Sumter City-County Planning Commission

HCPD-24-20 (Revision 1), 70 S. Guignard Dr. (City)

Request: Request for alternative exterior materials and roof form for new

multifamily apartment buildings.

Figure 2 - Colorized Rendering of Building #1 (North)

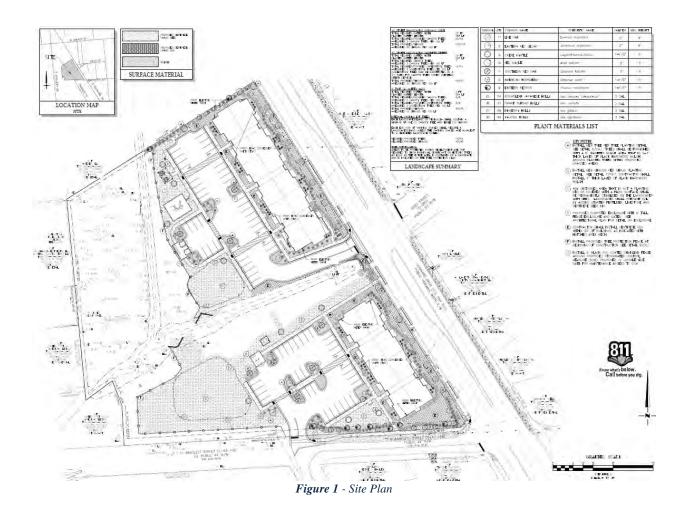
Staff Review: The applicant has submitted an HCPD revision application with elevations showing three separate materials to be used: Brick at 32%, Fiber cement panels at 47%, and fiber cement lap siding at 21%. Planning Commission approval for alternate exterior materials is required in accordance with the above requirement. The proposed roof structure is also proposed for change from an open gable style to a hipped roof form.

Staff recommends approval of the request.

Figure 3 - Building Elevations for Building #1 (North)

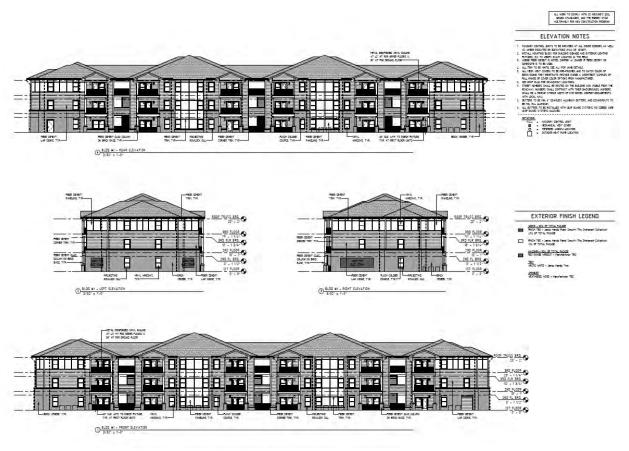
HCPD exterior material requirements are applicable to all sides of the building visible from public right-of-way. Fiber cement lap siding is a durable material that presents a visual appearance similar to wood siding, and fiber cement panel siding is likewise durable and presents a visual appearance similar to stucco.
